What do Cays residents want in Cays Park?

KEY FINDINGS from the 2021 & 2023 Surveys

Kevin Reilly
11/1/2023

COMPROMISE SOLUTION

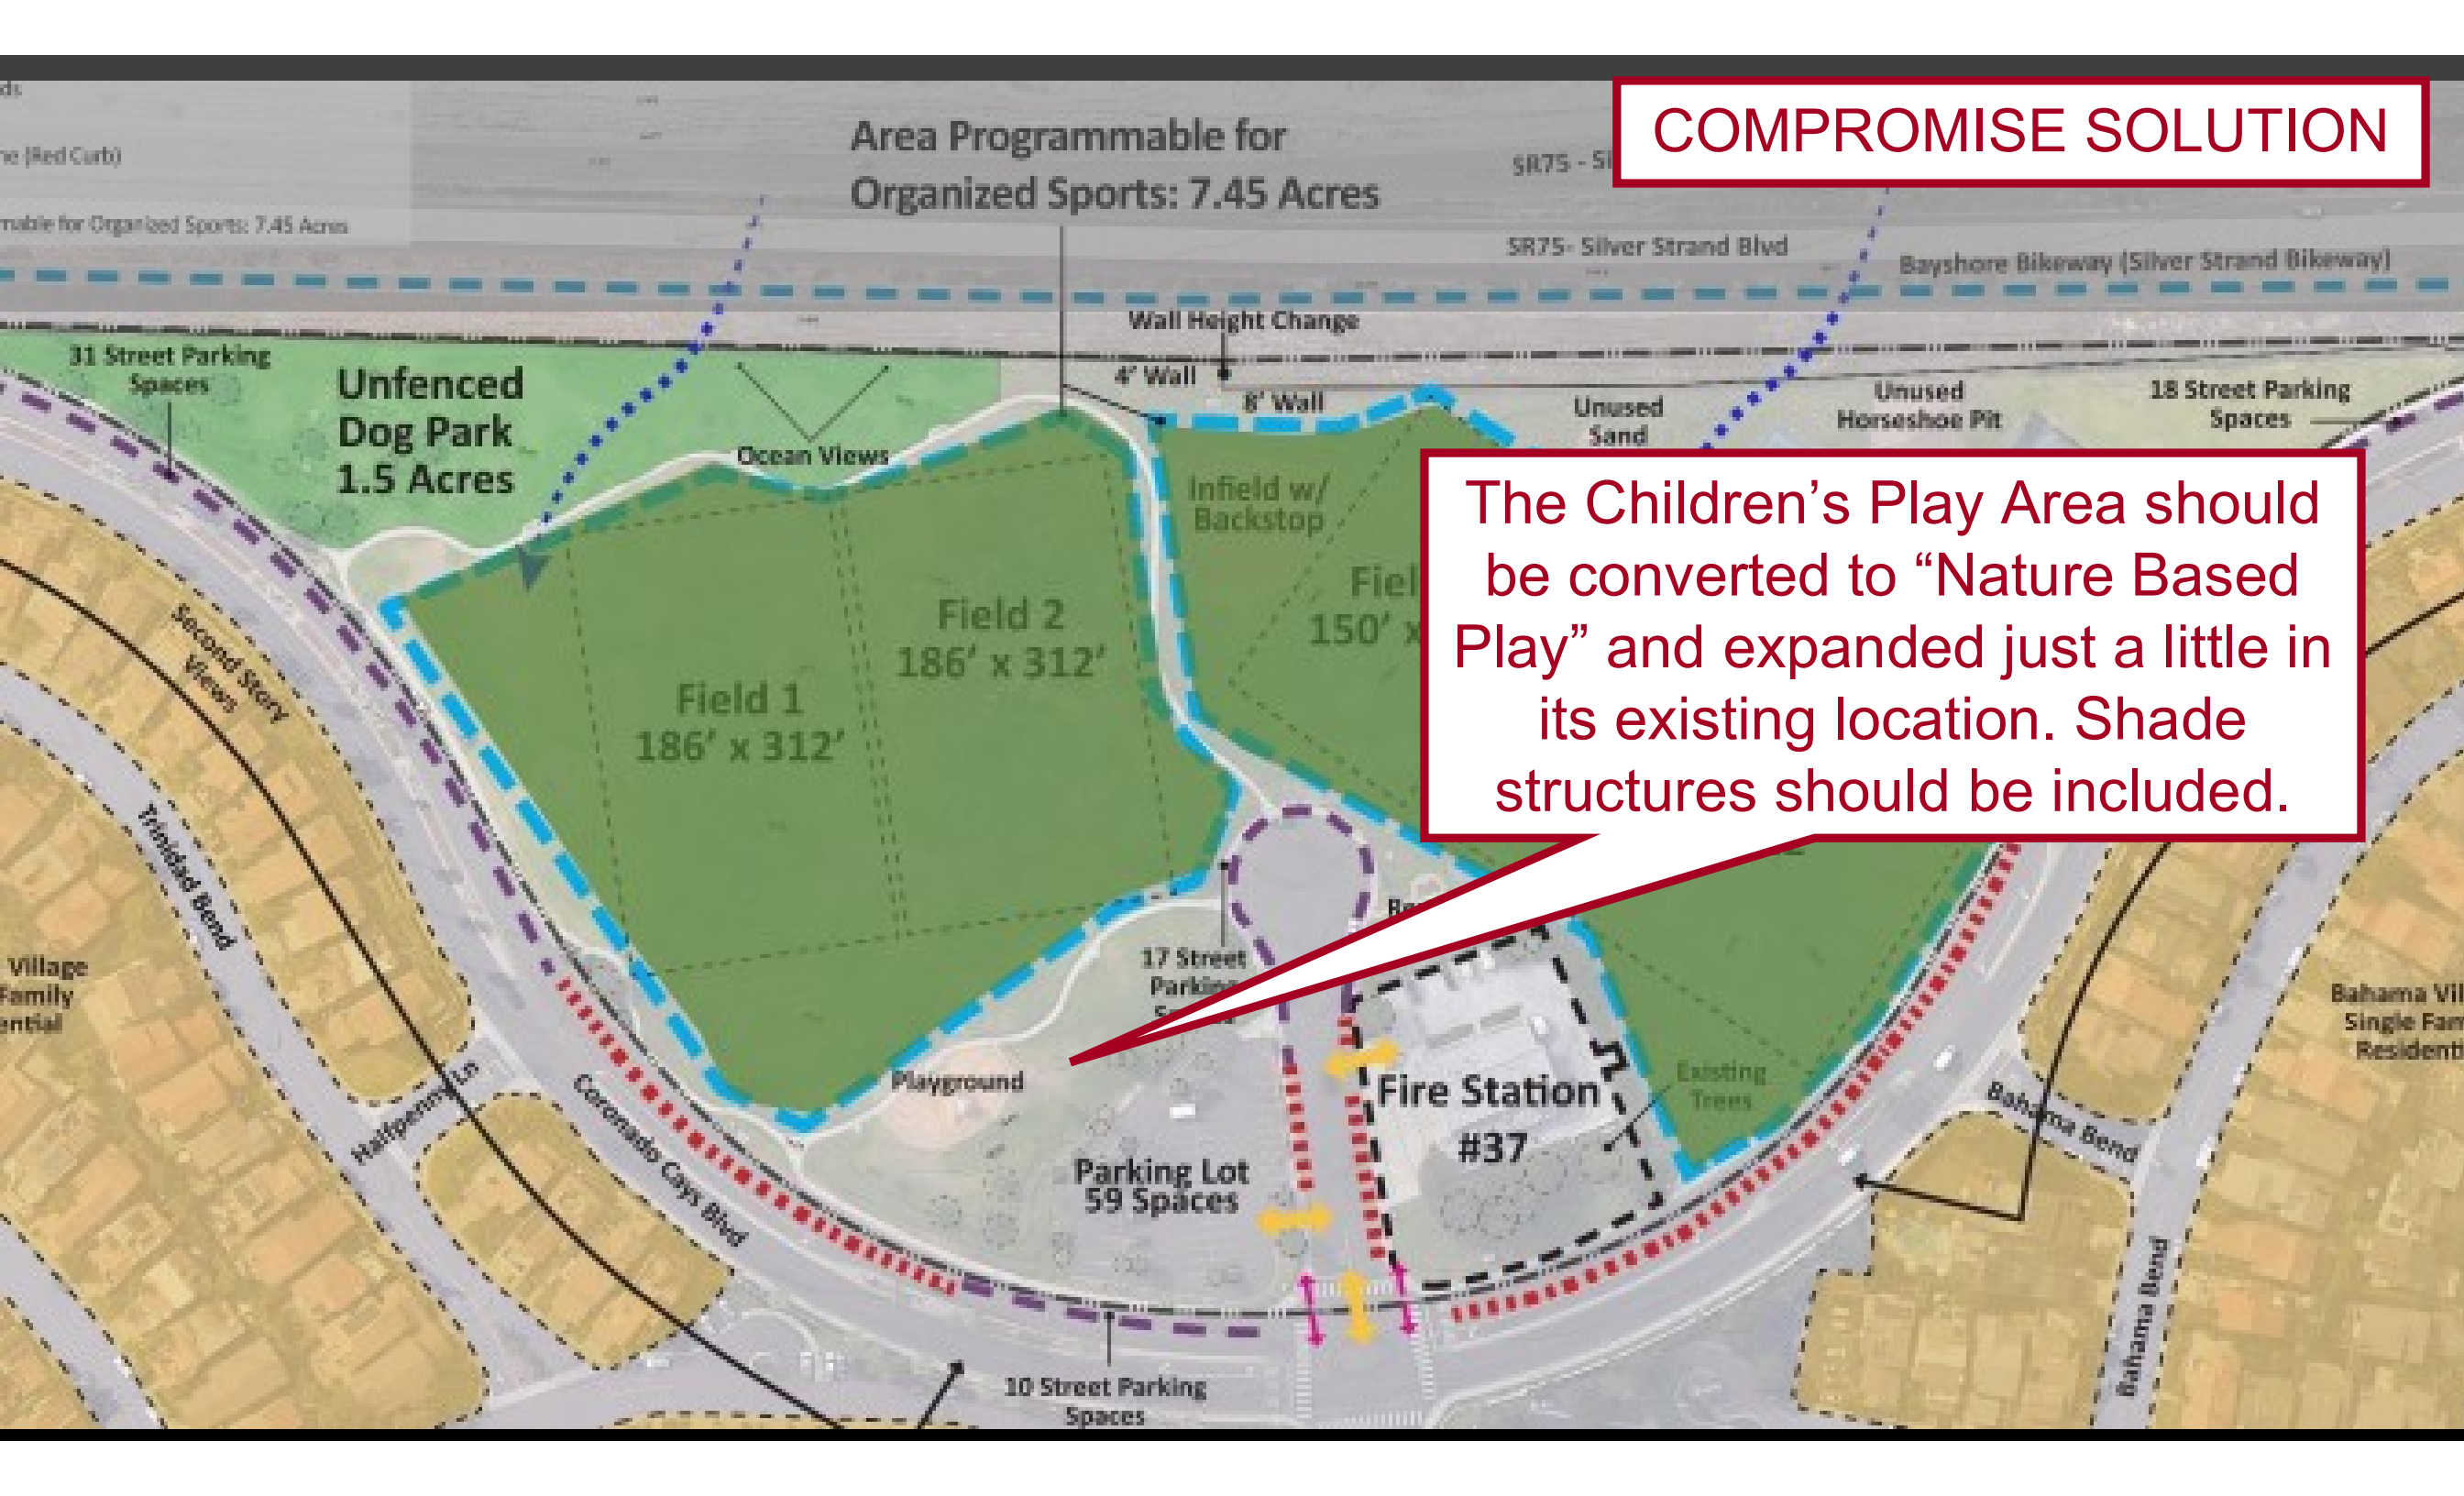
This area (Fields 1 and 2) should be landscaped and turned into a dedicated Passive Recreation space for Cays residents and the public at large.

OVERALL PROPOSED PLAN

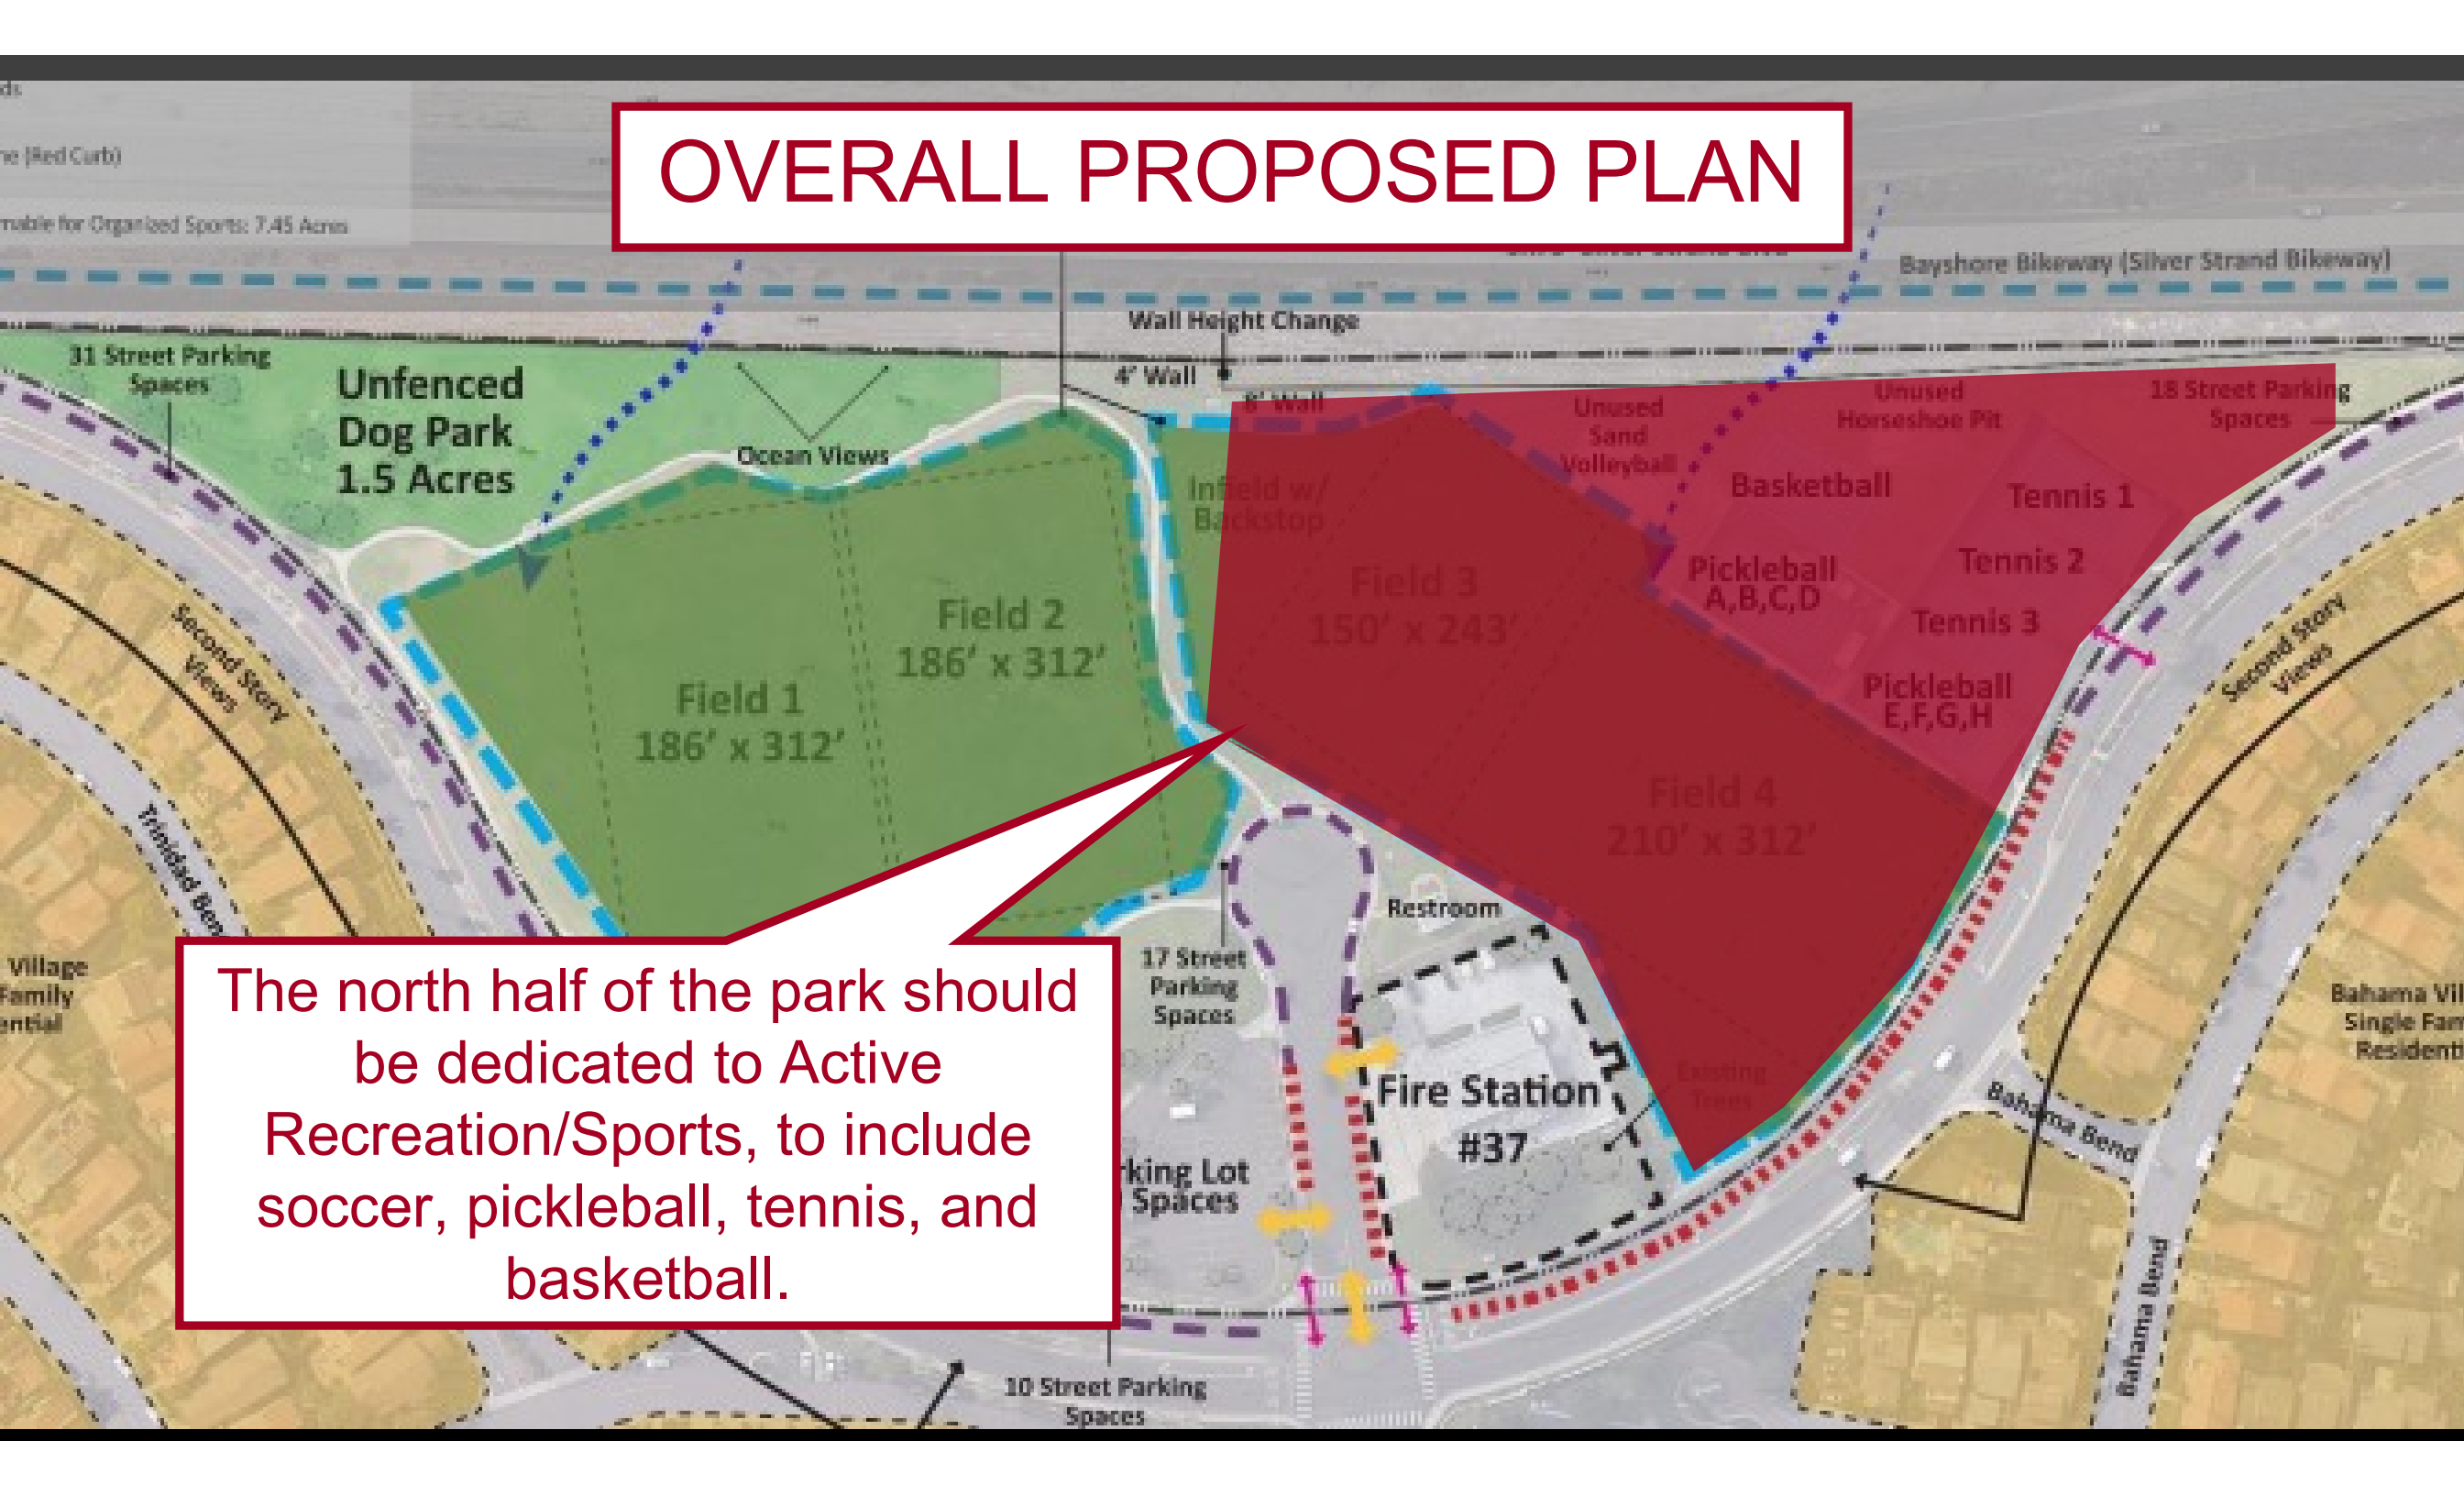
The north half of the park should be dedicated to Active Recreation/Sports, to include soccer, pickleball, tennis, and basketball.

PROPOSED PLAN OVERVIEW

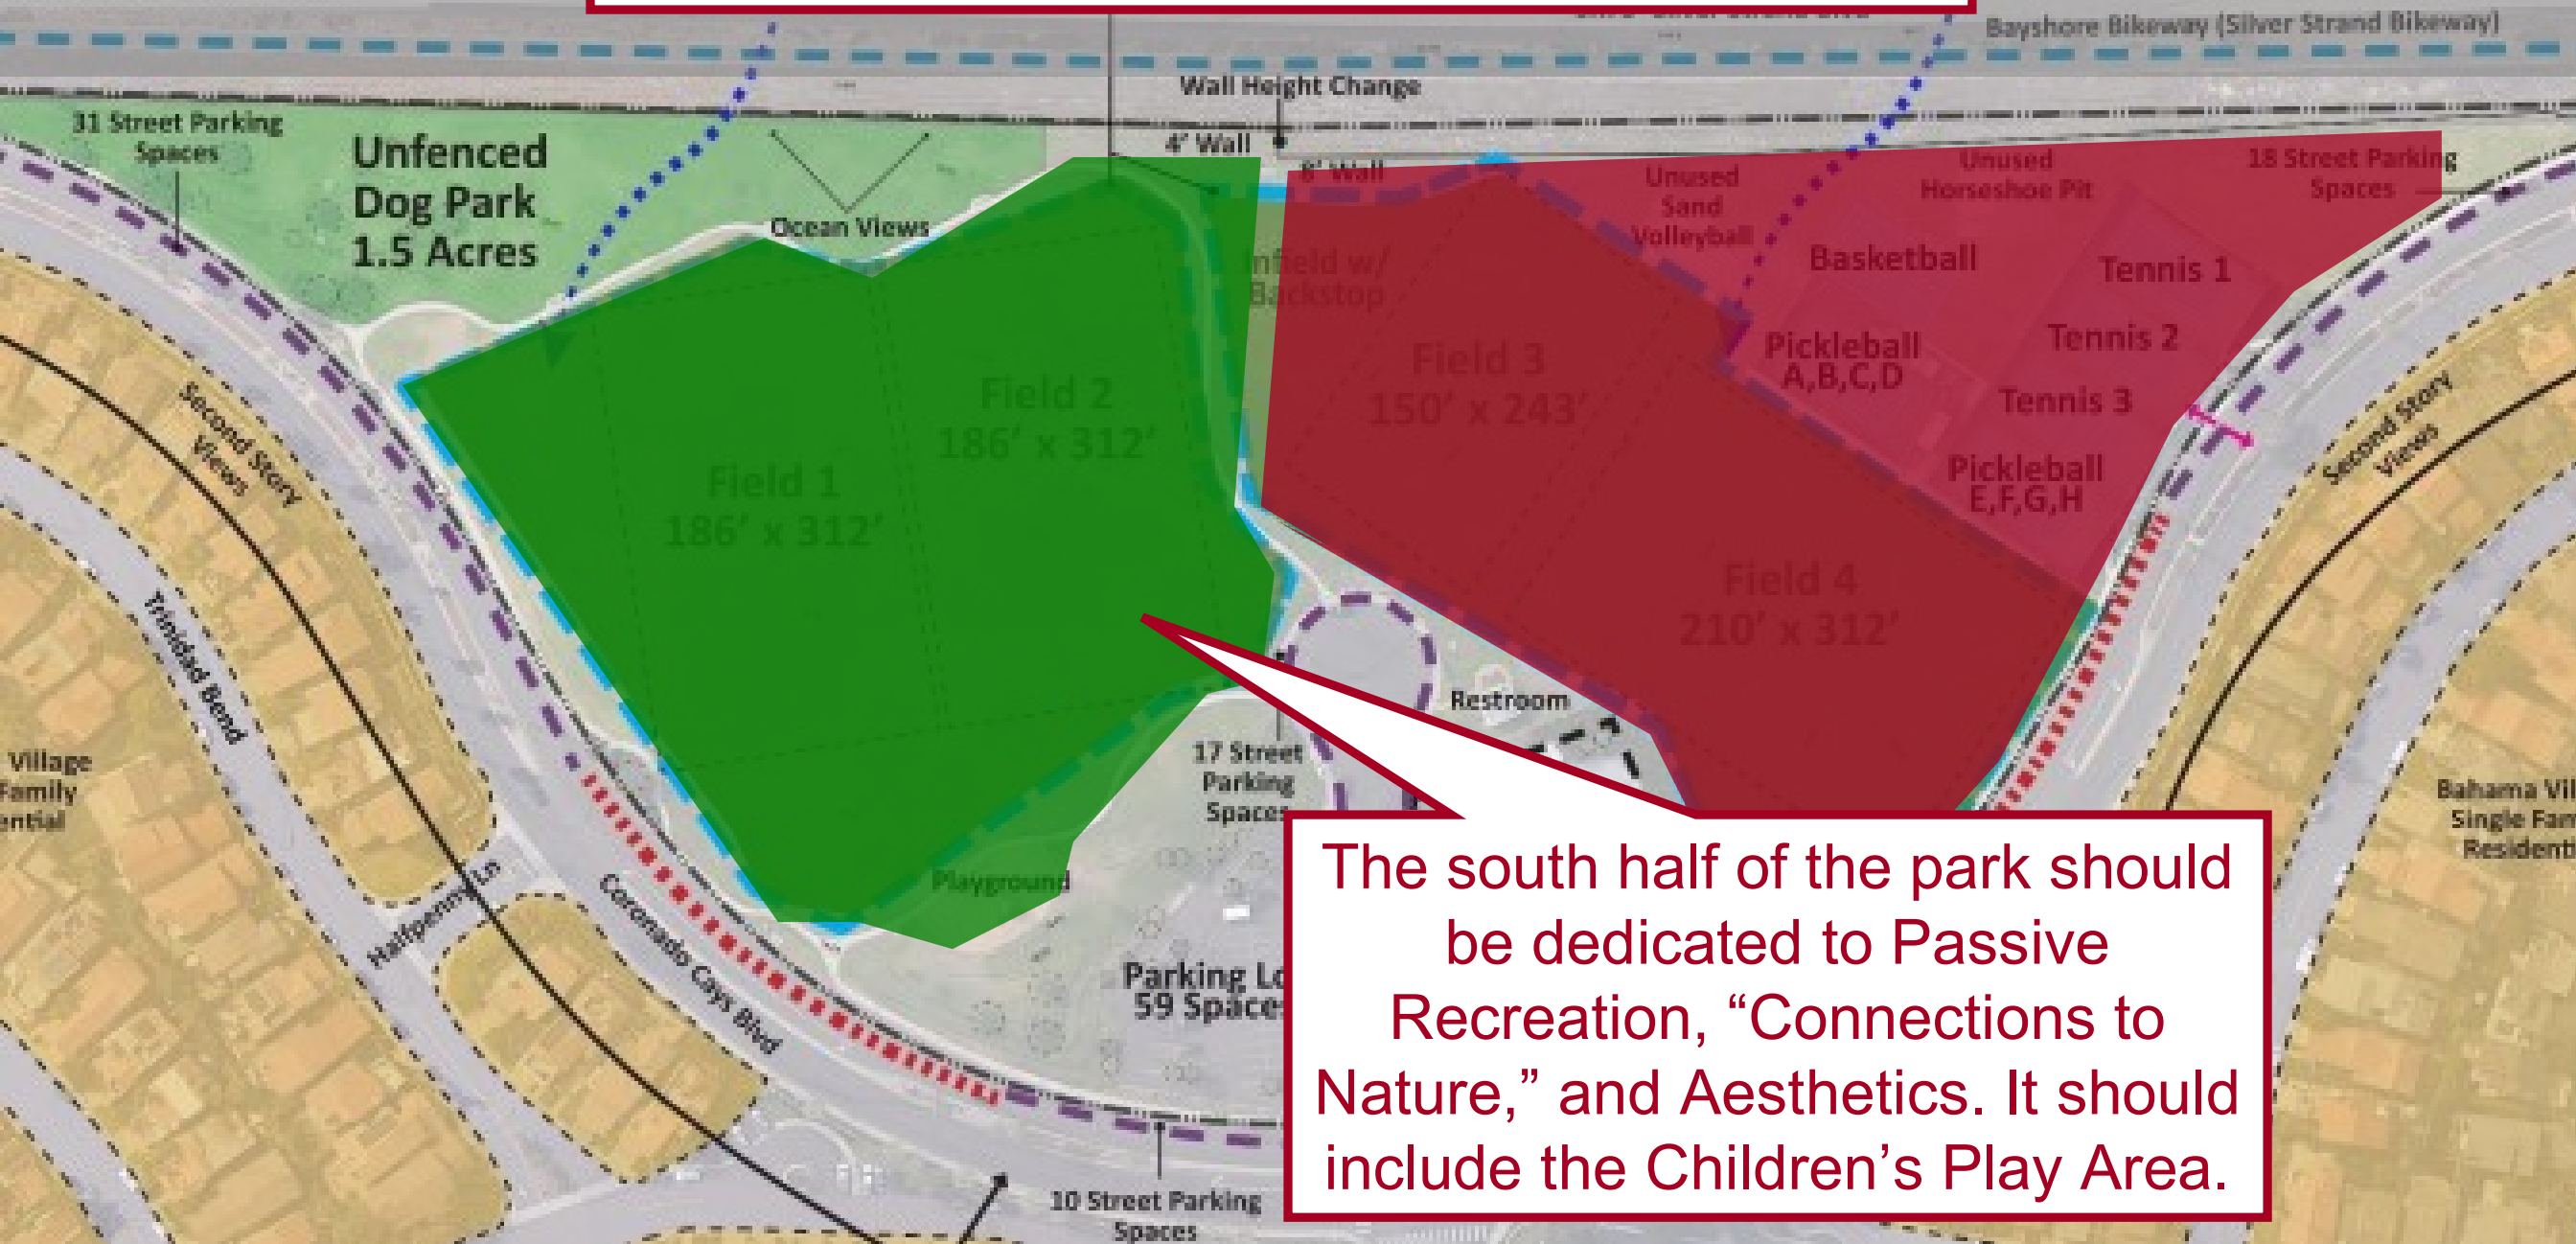
The south half of the park should be dedicated to Passive Recreation, "Connections to Nature," and Aesthetics. It should include the Children's Play Area.
